The landowners, [REDACTED], of 1805 South Gippsland Highway Clyde, make this submission to the Casey Fields South Employment and Devon Meadows Precinct Structure Plan (CFS&DM PSP), the Casey Fields South Employment and Devon Meadows Development Services Scheme (CFS&DM DSS) and Planning Scheme Amendment C295case.

Beveridge Williams makes this submission to the CFS&DM PSP, the CFS&DM DSS and Planning Scheme Amendment C295case on behalf of the Kevin Jones and John Payne, landowners of 1805 South Gippsland Highway, Devon Meadows. This submission addresses the land identified as CF-19 in the PSP Land Use Budget, which is approximately 9.72 hectares in size. This property is located at the north-western edge of the Casey Fields South PSP, with frontage to the South Gippsland Highway.

Technical Memorandum: Review of MW Proposed DSS for Casey Fields South (Employment) and Devon Meadows PSPs

Date: 31/03/2025
Project Number: 2101096, 2102129, 2300328
Project Name: Casey Fields South (Employment) & Devon Meadows PSP drainage strategy consultation
Authors: [REDACTED]
Reviewer: [REDACTED]
Version: 1

Figure 5: Extract from Plan 13 – Native Vegetation Retention and Removal (Source: CFS&DMPSP)

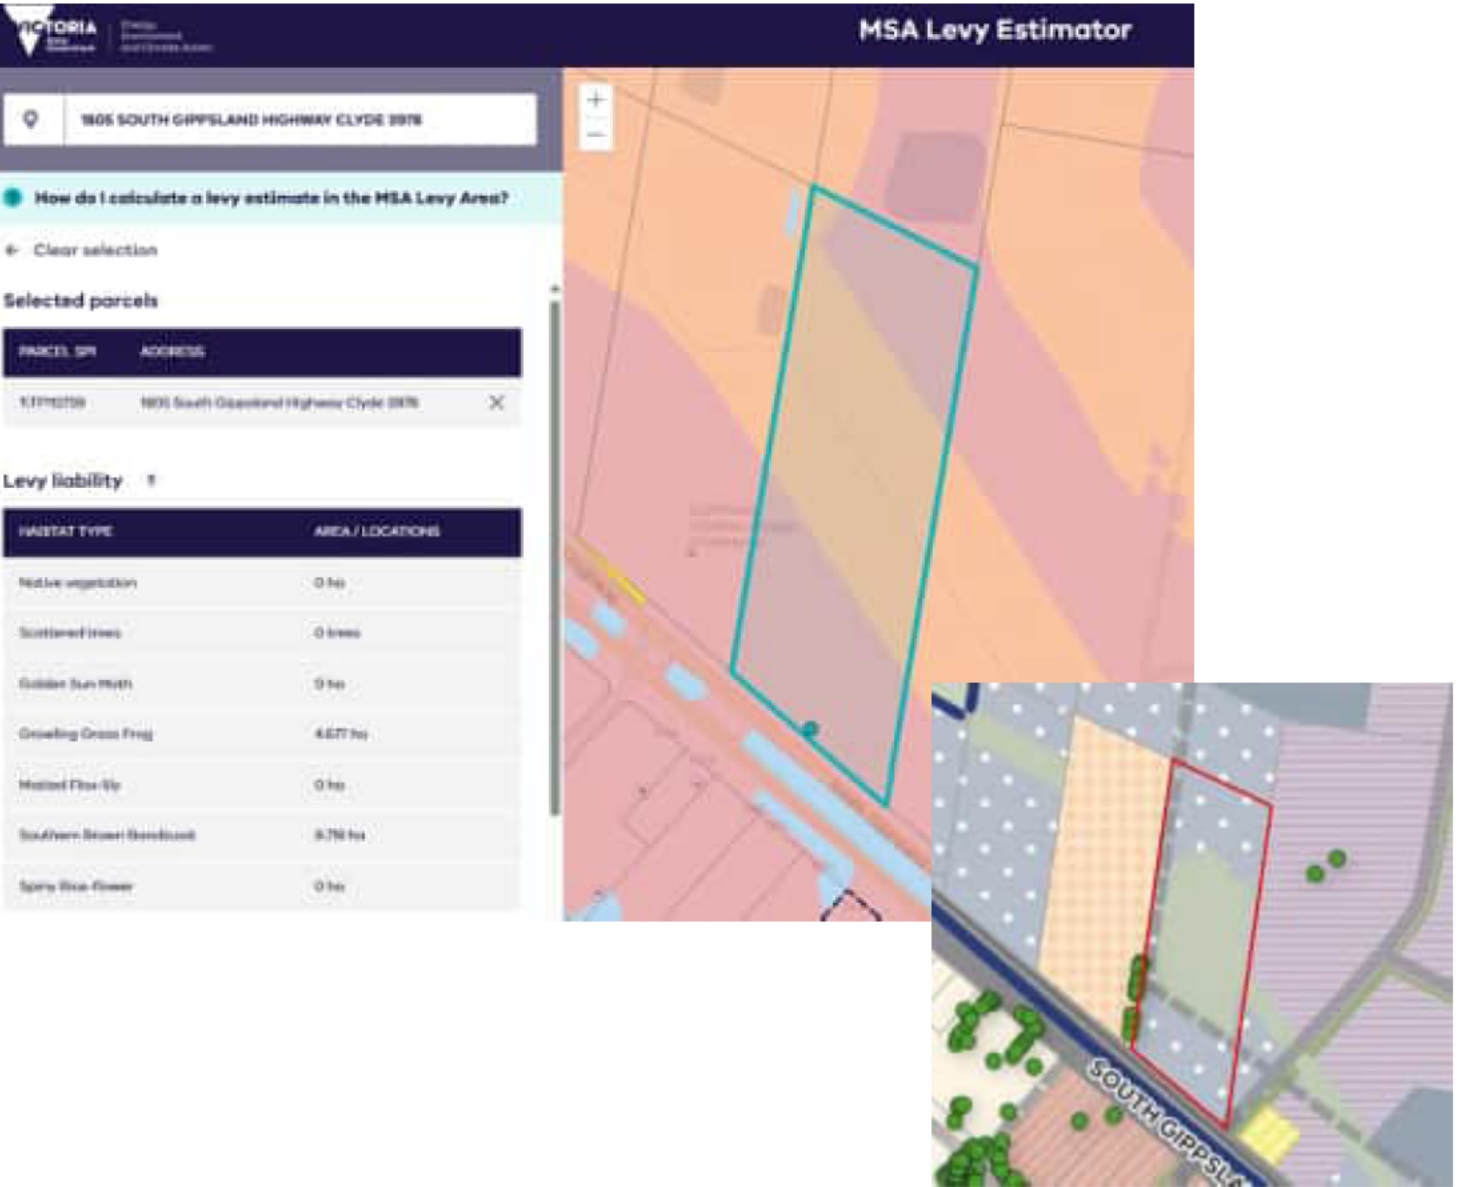
It is submitted that the trees designated for retention as nominated in PSP Plan 13 not so highly regarded that they justify protection. The Arboriculture Assessment makes the concluding statement that *'Industrial development of the area is expected and if it proceeds as is typical for such development, it is expected that most of the current trees will be lost'*. Further, the assessment recommends the preservation and protection of the 2 Critical Retention value and 258 High Retention value trees, of which the subject land does not encompass.

As a Regionally Significant Industrial Precinct, **It is submitted that all trees identified for retention on the subject land be removed from Plan 13 to avoid future compromises in the logical and efficient subdivision layout. Prioritising the functional layout of the precinct should take precedence over retaining these trees. Accordingly, Plan 13 which specifically relates to native vegetation should identify these trees as lost, consistent with the Melbourne Strategic Assessment (MSA).**

Long Section of the Diversion Channel Between DM2 and DM3

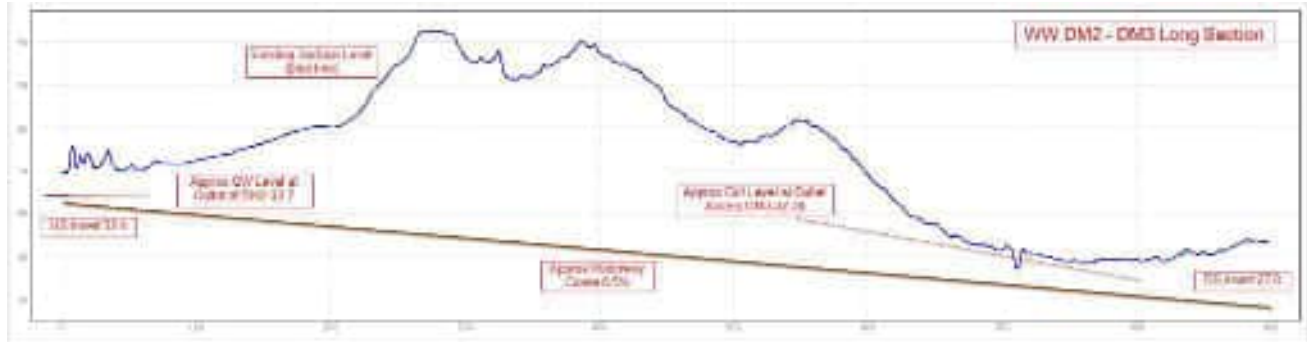
- At its deepest, up to 10m of cut will be required which, with the proposed 1:5 batters, could require a reserve width of up to 100m at its widest rather than the 45m shown on GHDs concept plan. This would require a significant volume of earthworks to achieve with the associated significant cost.

- In summary, the proposed channel appears to be a drastic and expensive measure directed at solving a problem that was not properly assessed/quantified. It does not appear to even resolve

the perceived issue, instead just relocating it to a different location. We recommend abandoning the diversion channel proposal and focusing on a different solution to protect homes in Devon Meadows.

Central Crossing (CFS4 to CFWRd)

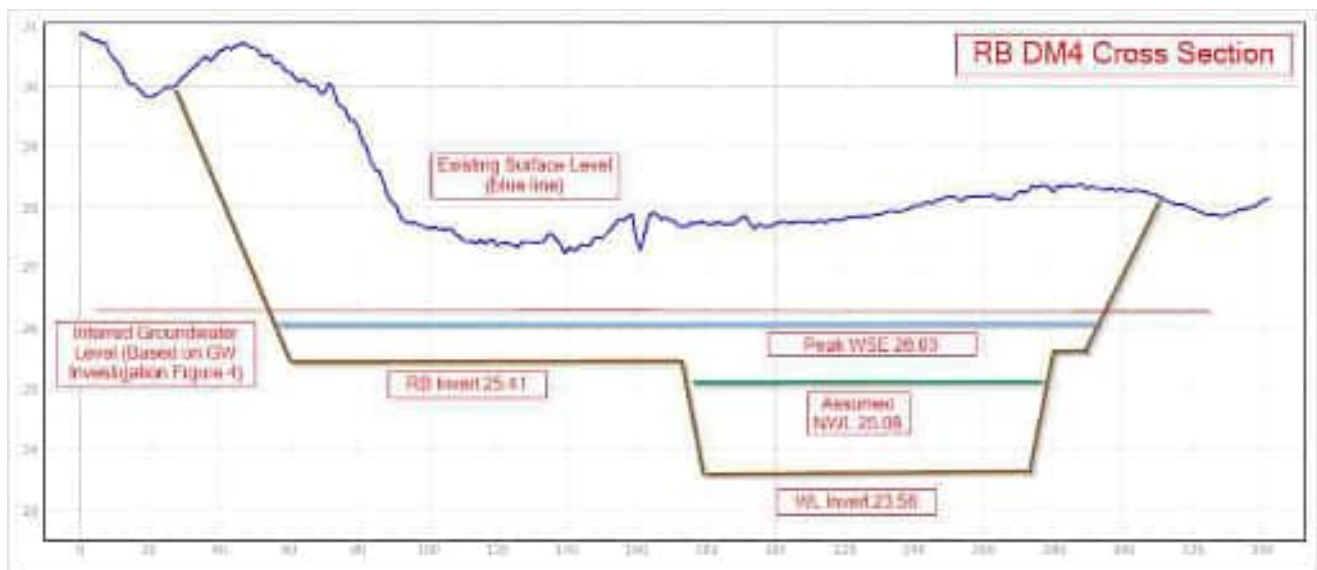
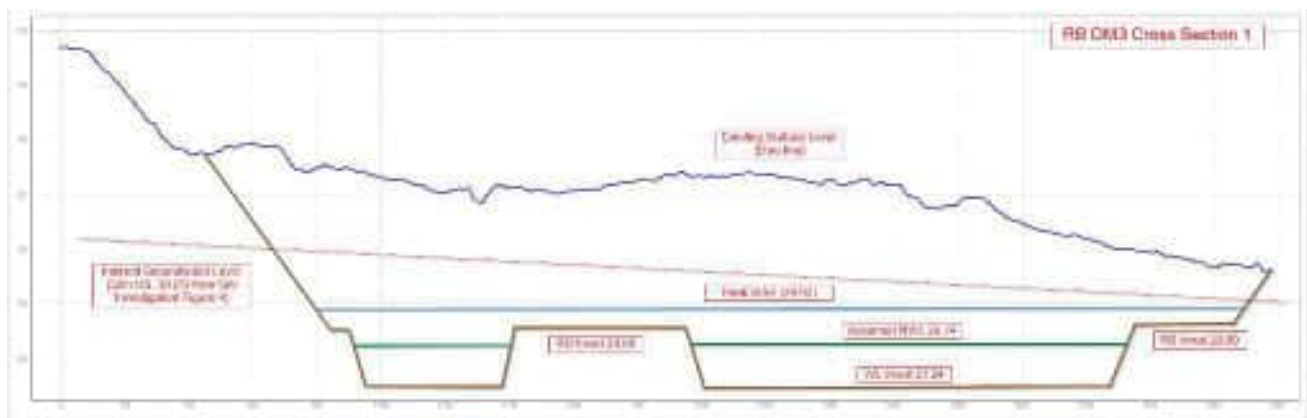
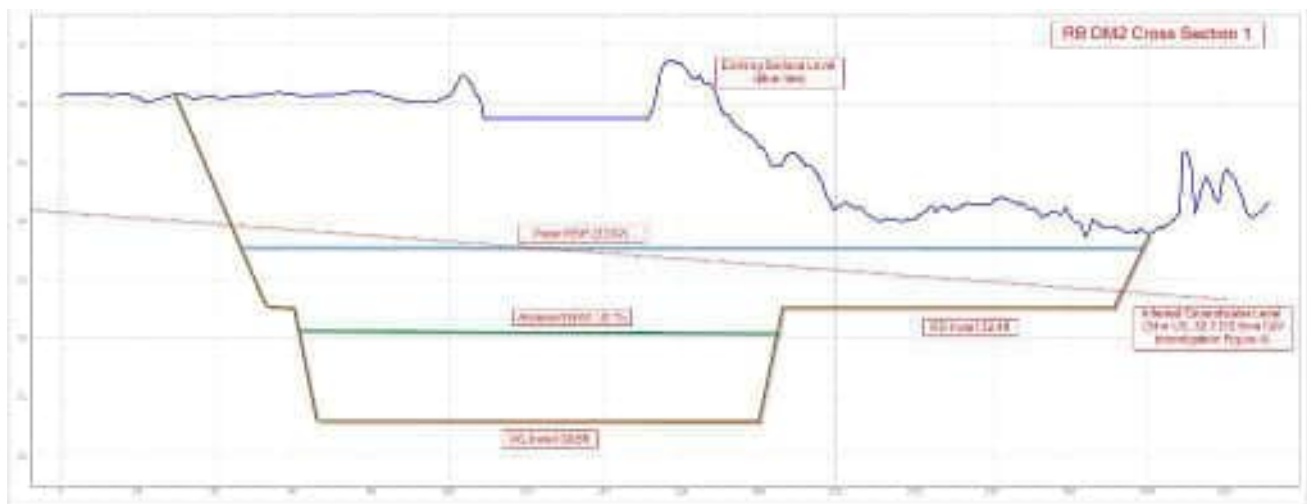
- **Connection Points and Impact to Landowners in Clyde South**
 - At this time, the proposed strategy relies on 3 connection points (shown in images below)

- We would recommend that further analysis be undertaken to address the above questions prior to adoption of the proposed strategy.
